MEMO

TO: Design Review Committee

FROM: Sarah Schafer, Manager, Design Review and Historic Preservation

RE: DRH17-00530 | Home 2 Suite by Hilton

South Elevation

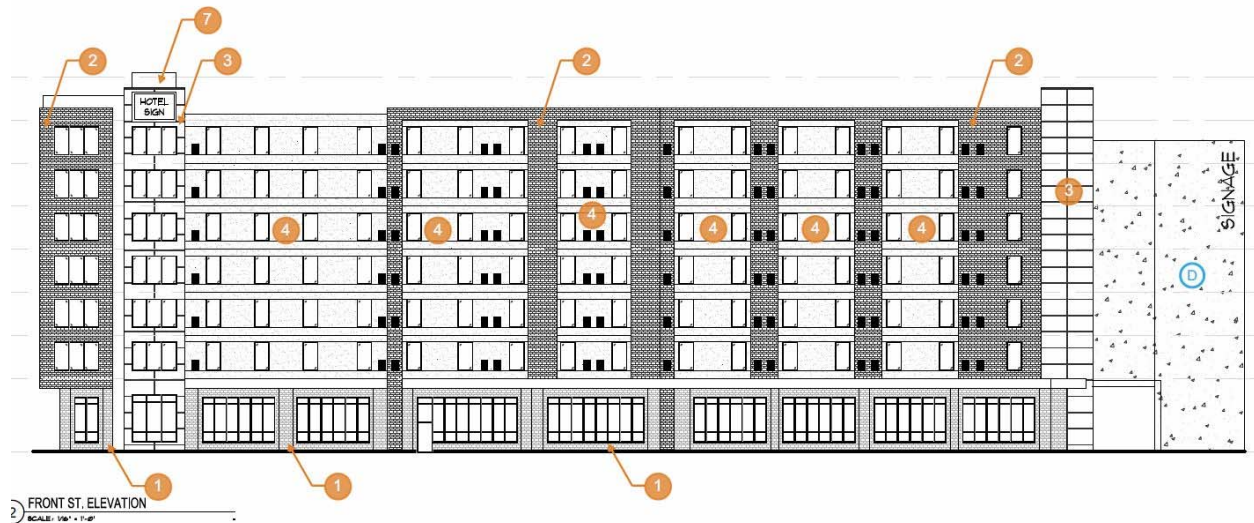
Through the elevation comparison seen above starting from left to right, there are changes in the left side of the upper levels of the structure. The bay of three windows were moved to the east. The material at the corner is a wood panel with an internally illuminated hotel sign (sign not approved under this application). A utility sized faced brick with no given color has been shown. The Exterior Insulation Finish System is used for the next two bays of the upper level. As the eye moves along the elevation to the east, there are changes in the material and changes in the height of the parapet line. Overall, the applicant has removed the use of the metal panels on this elevation, but has increased the use of the brick finish on the upper levels. At grade the metal panels are used above the storefront glass with the stone finish below the windows and between the window bays. This is a new material introduced to the project. A new material palette should be provided to the Committee for the hotel based on the current design.

The natural honed concrete with the exposed form ties on the parking structure shall be appropriately finished, sanded down after being hand packed and all efforts shall be made to have the concrete finished in the same color. An integral color concrete to ensure this should be considered.

On the parking structure where the custom metal fin is used as a cladding system, there was previously a "frame" around the fins. This has been removed from all elevations. The south elevation now has a series of fins visible and the frame should be used. At the base of the structure at the garage, adjacent to the park, there should be a partial wall to separate the parking structure from the adjoining parking to reduce the visibility of the cars parked within the structure from Front Street. The applicant through drawings submitted on April 11, 2018 but date stamped into the system on April 27, 2018 is proposing landscape in the pocket park to screen the parking at this location. They stated as part of the April 11 work session that the access from the accessible parking to the site would be through the required partial wall the staff team was proposing. The landscape on the opposite side of the sidewalk would accomplish the screening, allow the accessibility and provide for the parking to remain. If the Commission is comfortable with the solution, recommended condition of approval 1s would need to be deleted.

It has not been shown how the blank wall space on the parking structure adjacent to the pocket park is to be reduced.

East Elevation

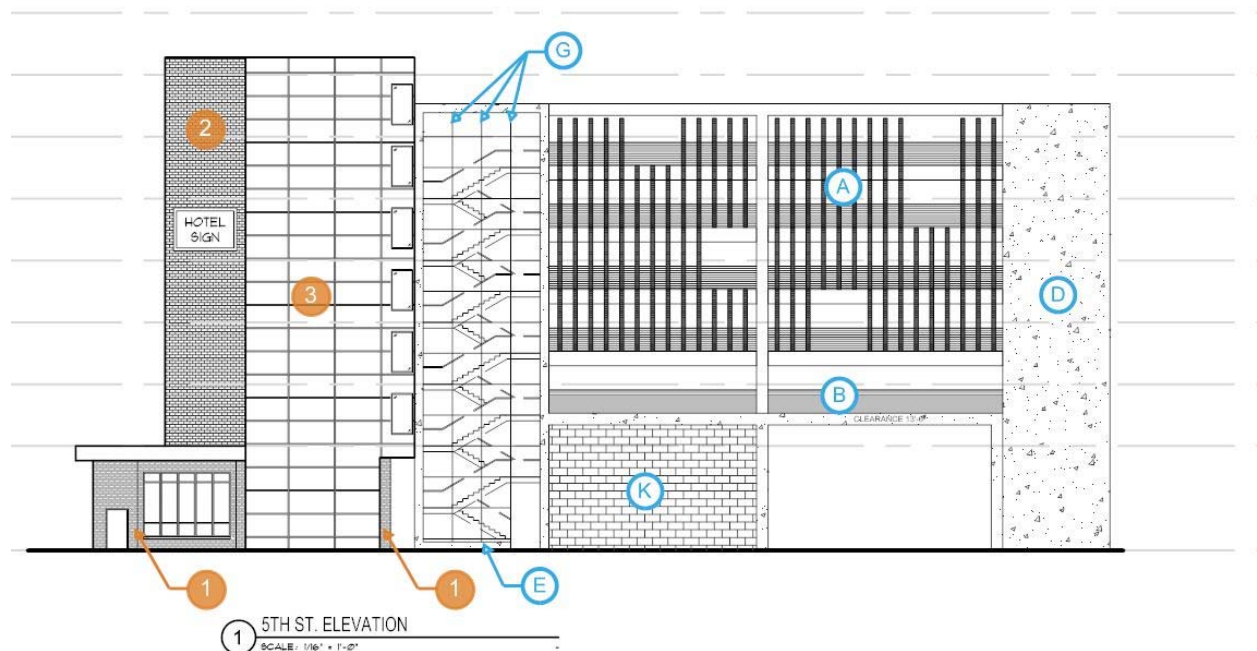
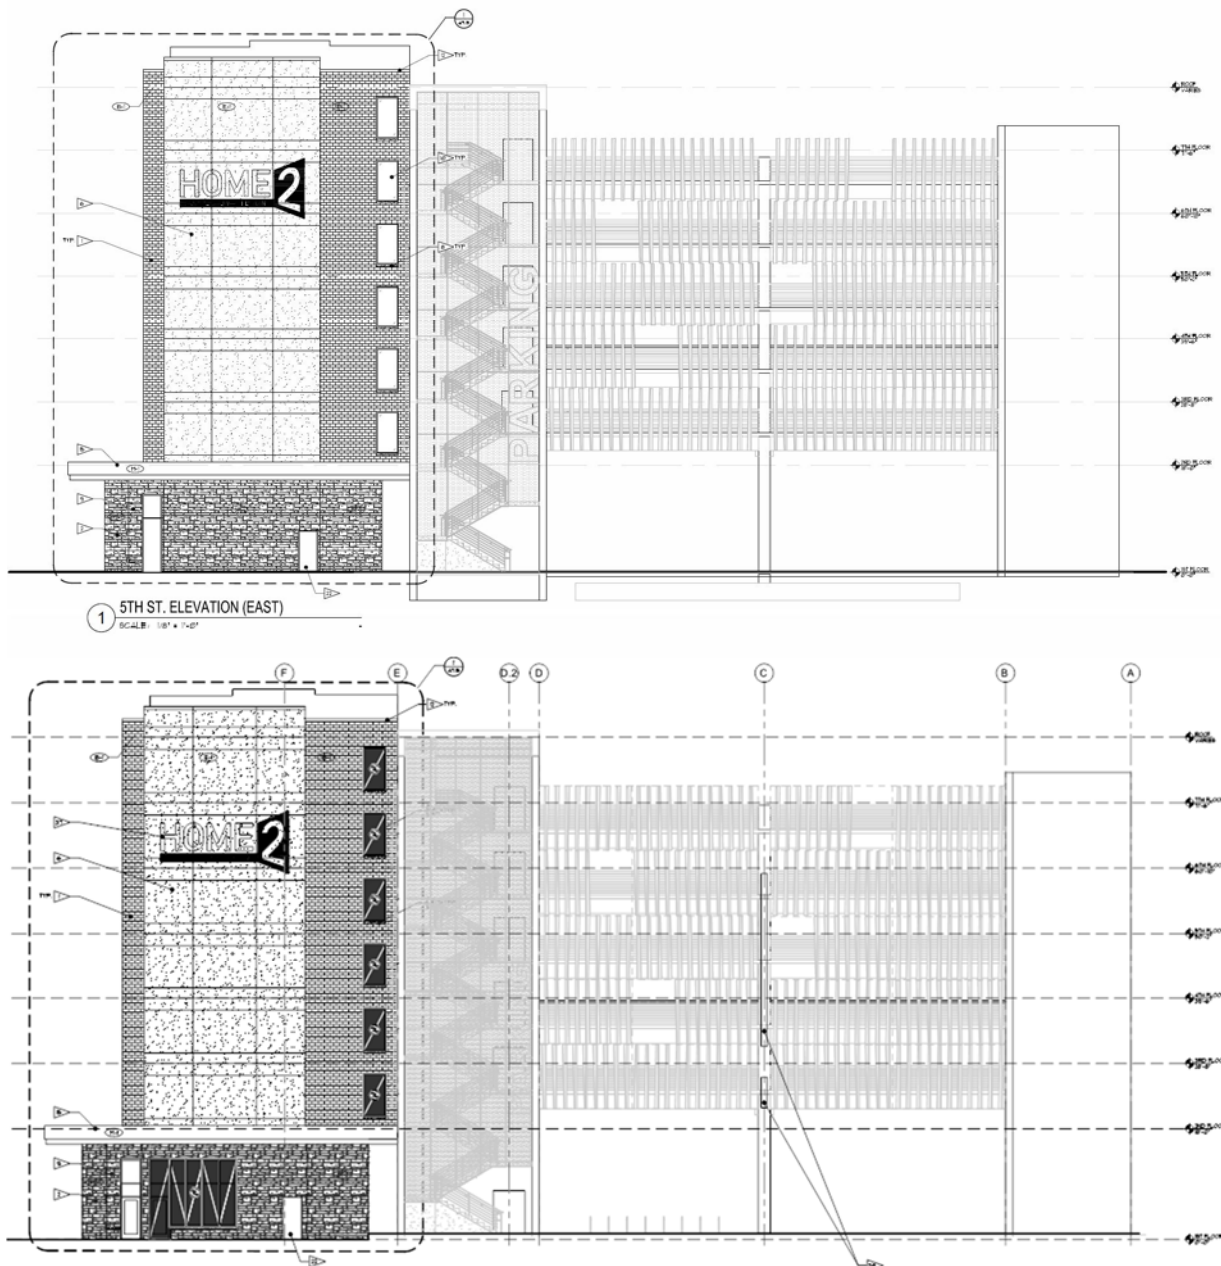
There is a lot of change in the materials on the east end of the building. The stone at the base of the hotel is no longer broken up with windows and leaves a large amount of blank wall space that will be highly visible to the flow of traffic. The frame around the metal fins on the parking structure should be replaced along both the top and bottom as well as around the openings. The frame should have a detail presented and show how it will work with the metal fins and be installed.

The last version of the east elevation shown above provides additional windows at the base of the building to break up the blank wall space at grade as required by the design guidelines. These elevations satisfy recommended condition of approval

West Elevation

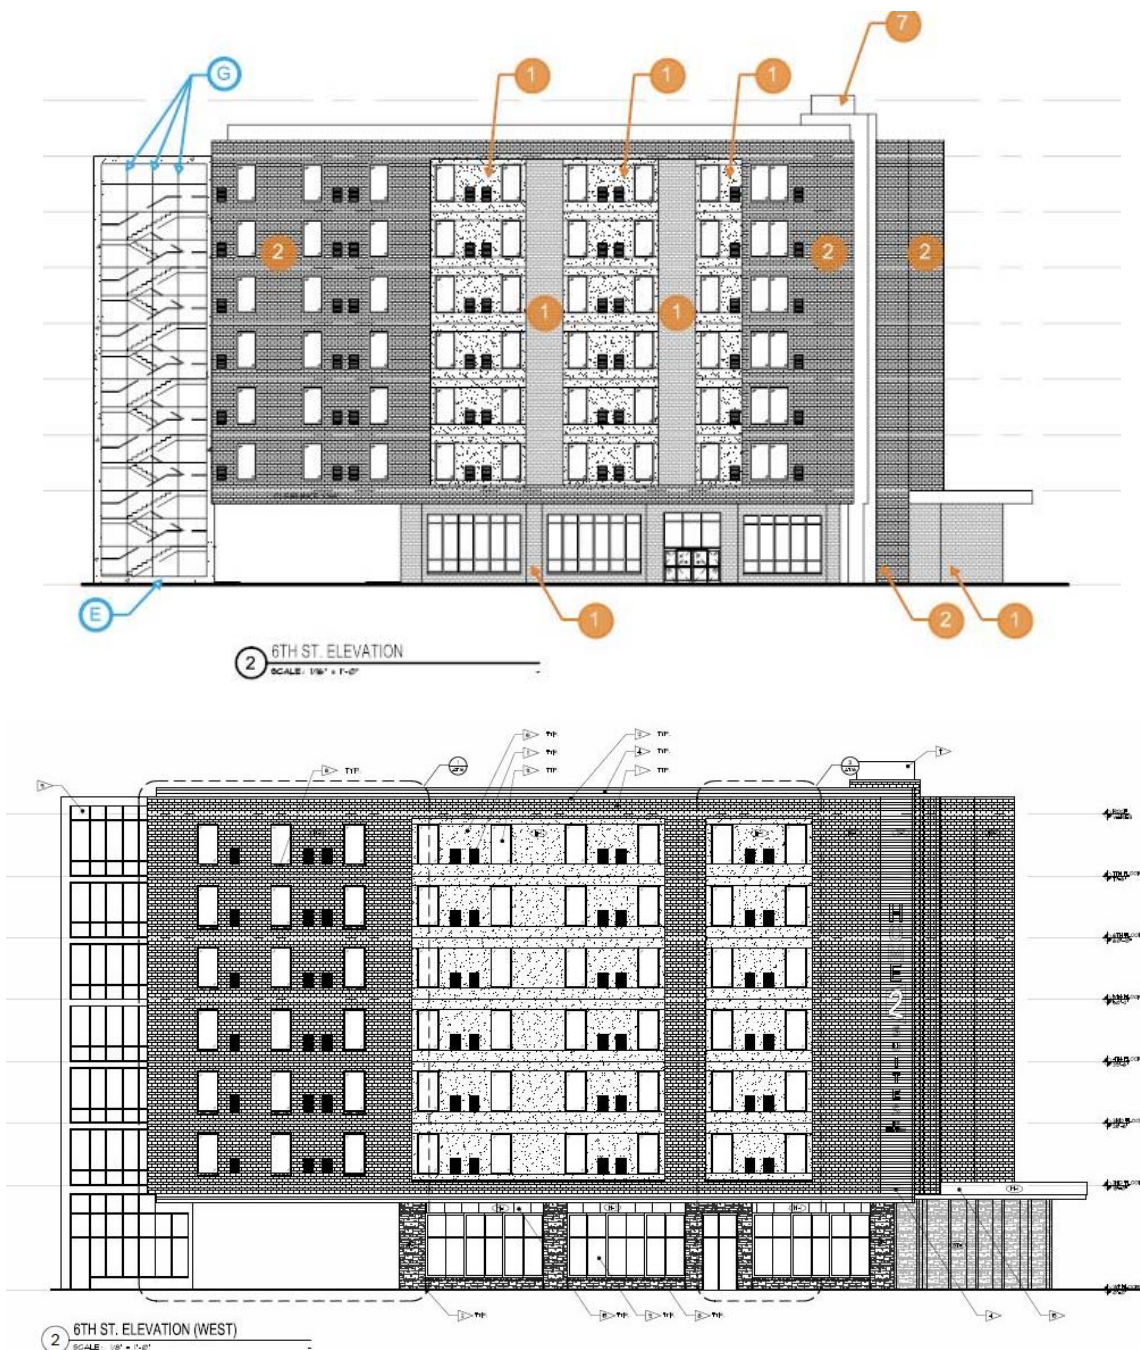
The west elevation is much the same in terms of massing and materials as the previous elevation. There has been refinement of the elevation as the project has progressed. The stair tower has been formalized with a glass enclosed stair, brick covers the upper

levels of the hotel over the access into the hotel drop off area. The ground level of the hotel is the stone and storefront with the upper level finished with EIFS and brick. There is a little wood panel used along this elevation.

North Elevation

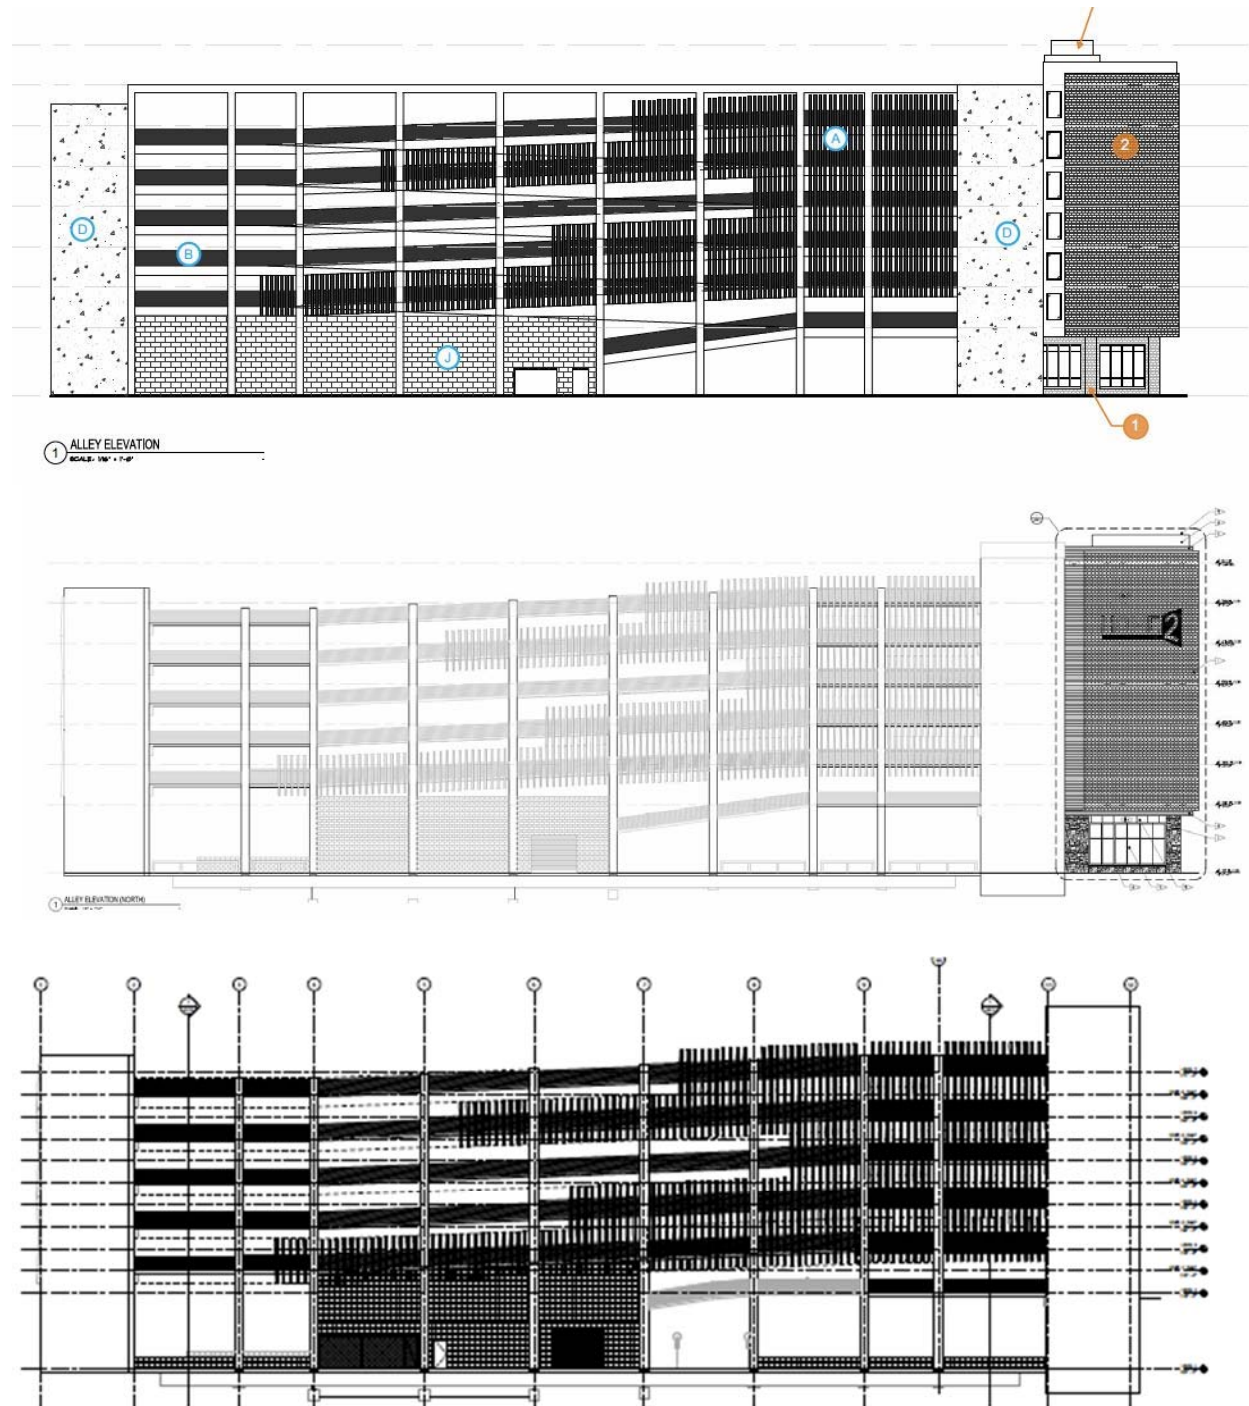
There are a couple of modifications on the north elevation of the structure like the other elevations. The framing in conjunction with the parking structure has been removed taking away a finishing cap for the metal fins and removing a finish look for the parking structure. This element of the design should be returned and the details regarding the materials and the connections should be provided. At the base of the building the wall adjacent to the alley has been removed and a half wall proposed along with a chain link fence to screen the generator. A recommended condition of approval is to replace the full height walls and to provide a mechanical screen/vent in place of the chain link fence at the generator location.

For the hotel portion of the structure on the north elevation, the brick is to remain on the upper portion of the elevation. The first level of the structure will have a stone finish with a metal panel above the windows. The sign shown on the elevation will need to be reviewed and approved under a separate application and building permit for size, location and construction.

Window Detail

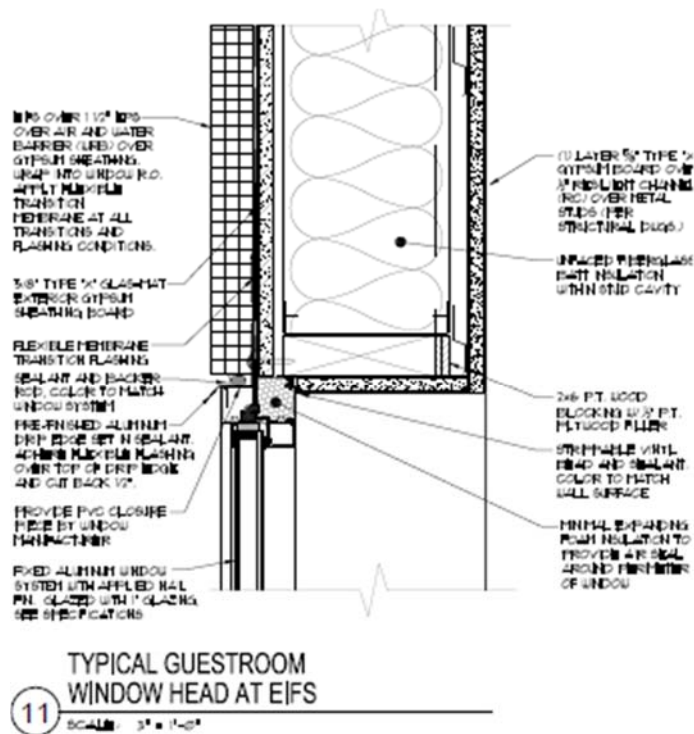
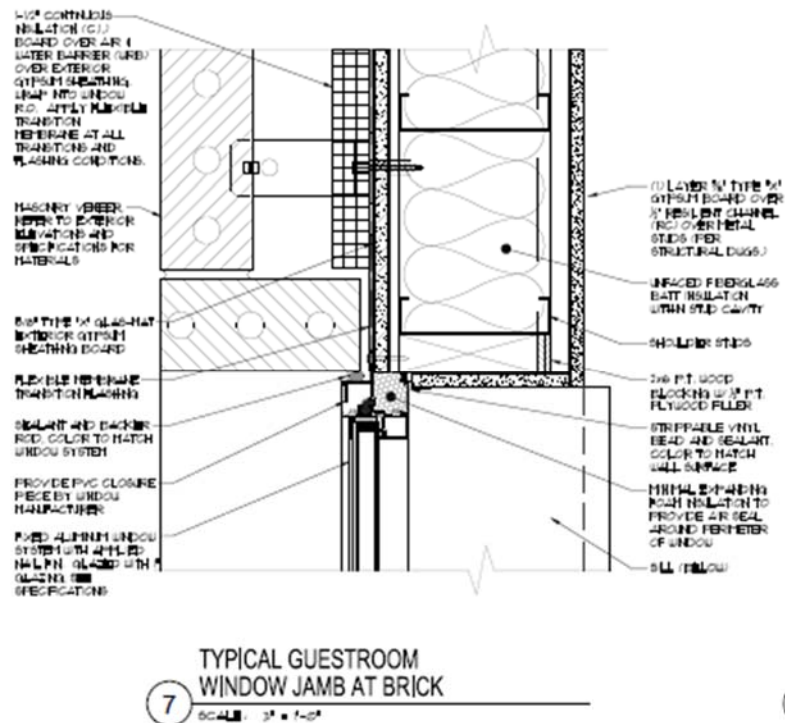
The window detail shows there is no recessing of the windows within the wall plane where adjacent to the EIFS.

The detail of the window at the location where there is brick show the glass recess from the finish edge of the brick.

The detail of the window within the EIFS wall plane should be recessed. It doesn't need to be recessed as far as the brick detail but should not be flush with the finish of the EIFS.

Sheet L1.00 shows the following:

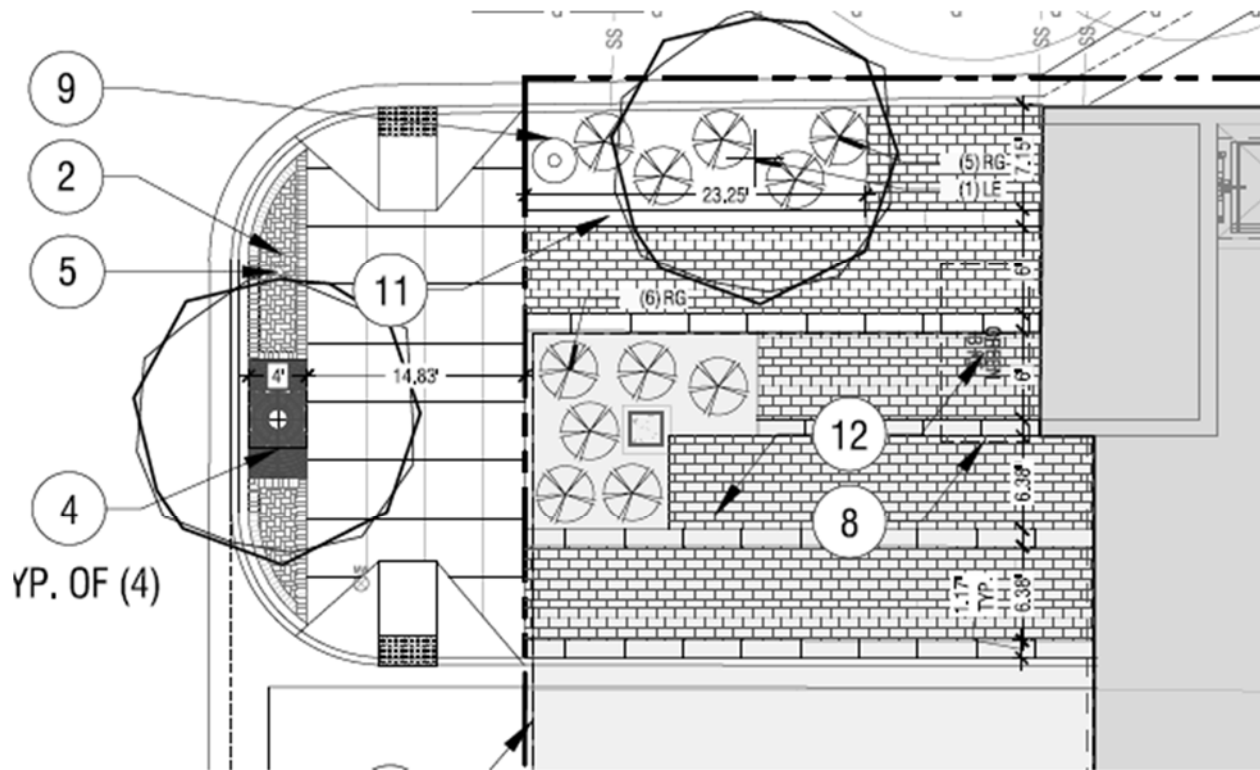
The sumac which quickly grows to a height of two to three feet is indicated within both planters. The Emerald City Tulip Tree is proposed for the planter adjacent to the alley. Bench seating should be considered around the other planter in the plaza to create a gathering space for the area and additional seating.

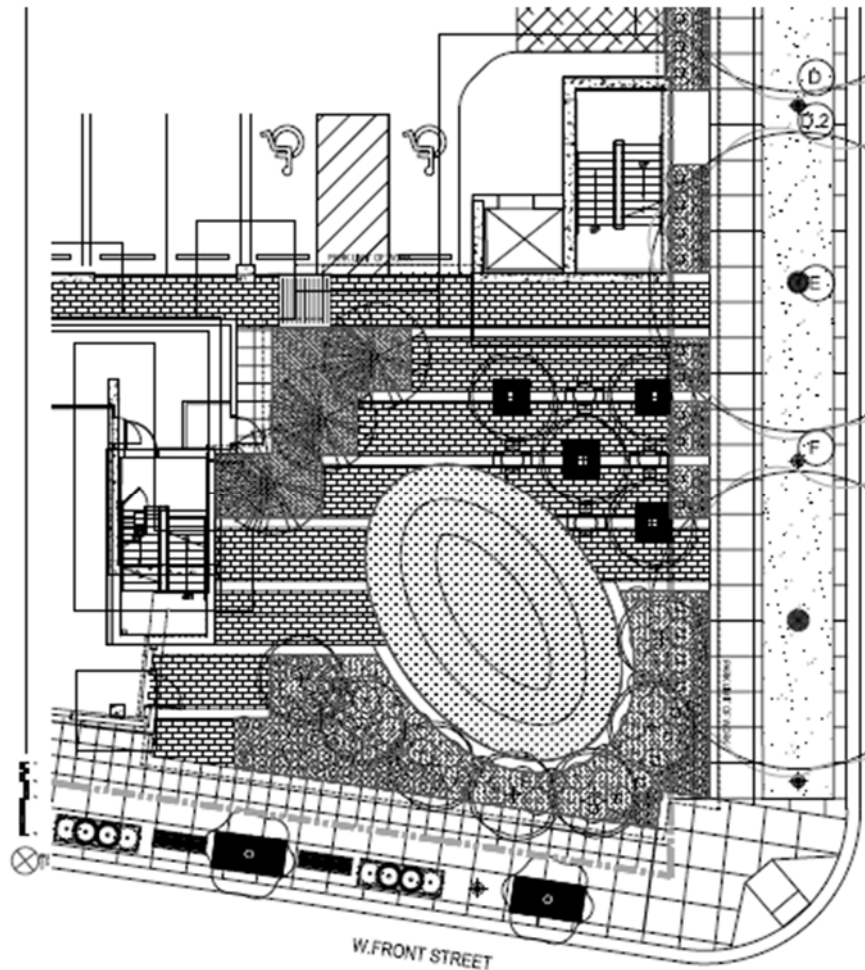
The pocket park at the southeast corner of the site has similar elements as the northwest plaza.

Dream Catcher Flowering Cherry trees and Balsam Fir trees are proposed for the pocket park. Turf sod is proposed for the oval at the intersection with some of the cherry trees within the planter spaces and four of them within tree grates throughout the plaza. For the trees within the tree grates, a suspended pavement system should be used to ensure the healthy growth of the trees.
